UNC Charlotte Phase 16

Addendum #4

Revision Narrative

2021-09-08

E-401S

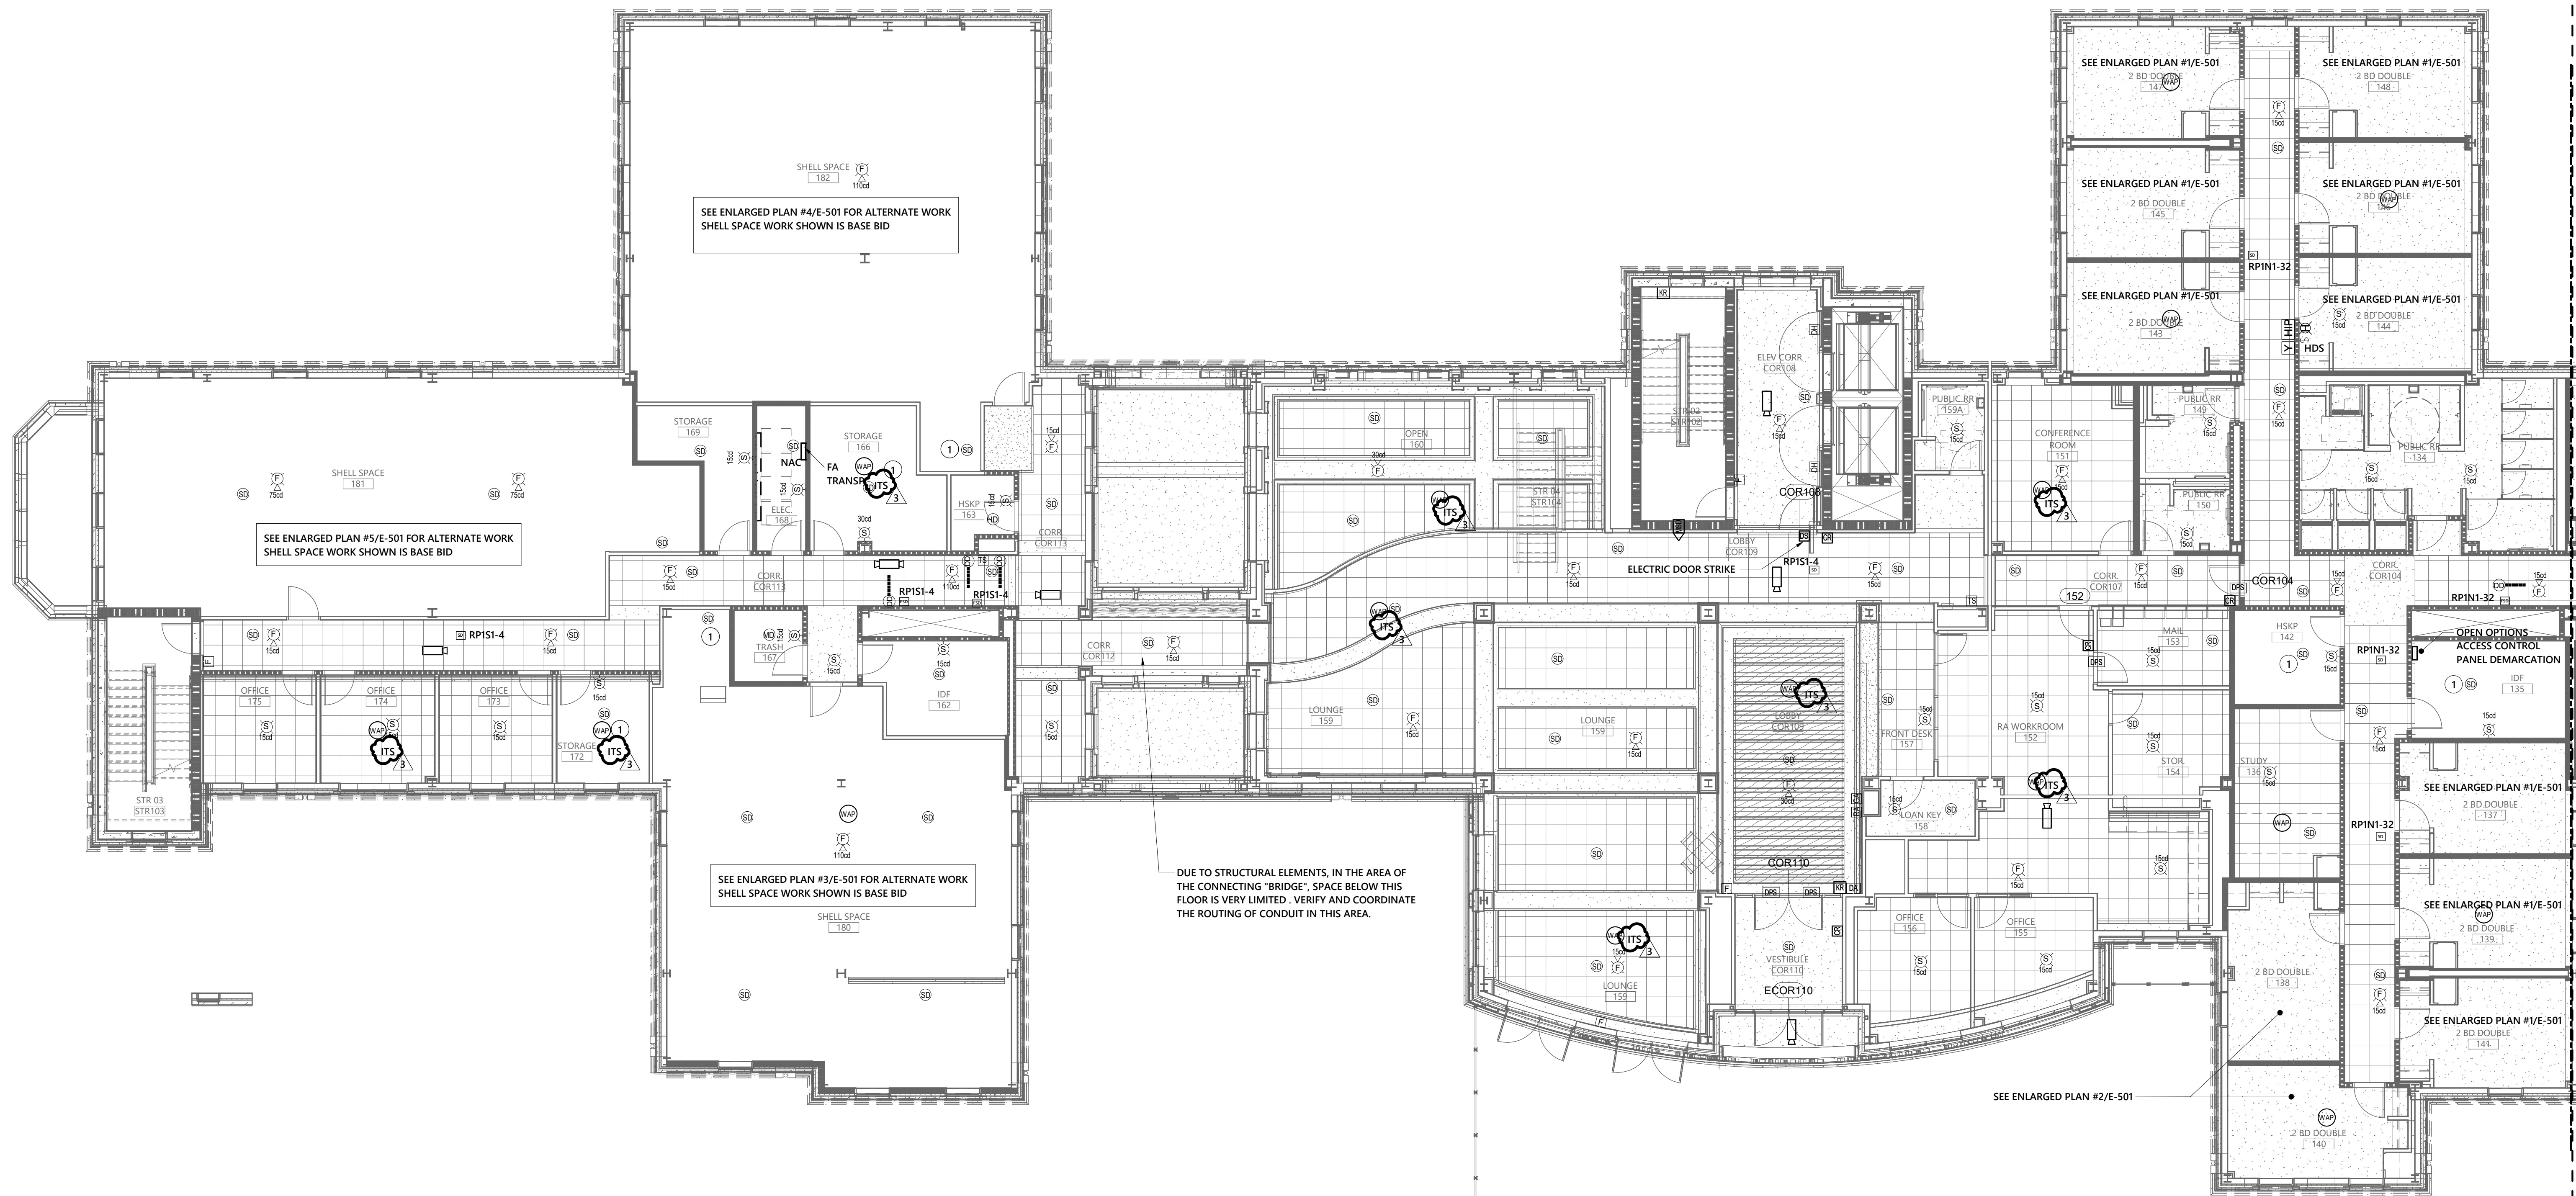
E-401S - ITS designations added.
